**Cobra Motorcycle Mfg.**

## TSB1408 CX50 JR / OI radiator

May 1, 2008

Figure A

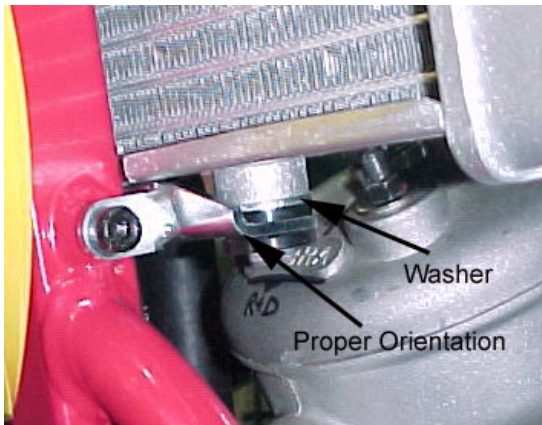
The radiator (ECMU0061) for the Cobra CX50 JR & OI is now silver and is being produced by a different supplier. Besides the change in color there is also a geometry change to the radiator. Most importantly the radiator is larger and so requires some changes to the mounting.

The part number for the new radiator is ECMU0225. When an ECMU0061 is ordered from the factory, an ECMU0225 radiator and new mounting hardware will be shipped. If an ECMU0225 is ordered just a radiator will ship.

1. The bottom radiator mount must now be mounted upside down from the previous mounting arrangement. Proper bracket orientation is shown in Figure A and there is a washer between the grommet and the radiator.
2. A spacer is supplied to aid in mounting the radiator in a true horizontal position. The spacer goes between the bracket and the frame on the upper mount (Figure B).
